CHEST FREEZER ABNORMAL ICE BUILDING – LOCK

Revision	Date	Description	Author	Approved by - on
00	06/2015	Document Creation	Lukasz Goraczko

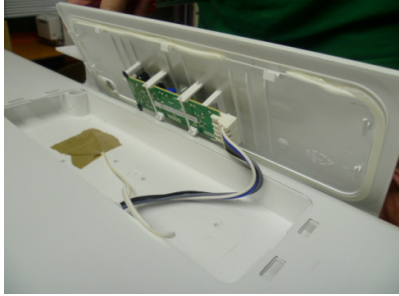
Warmer air can get into the appliance. The form of the ice build-up can show what the way of the air flow is. The ice can be concentrated around LOCK hole on the frame or formed inside of cabinet.

Repairing solution is to replace the “handle with lock” to a “handle without lock” version.

1. Screw out the lock

2. Pull out the lock
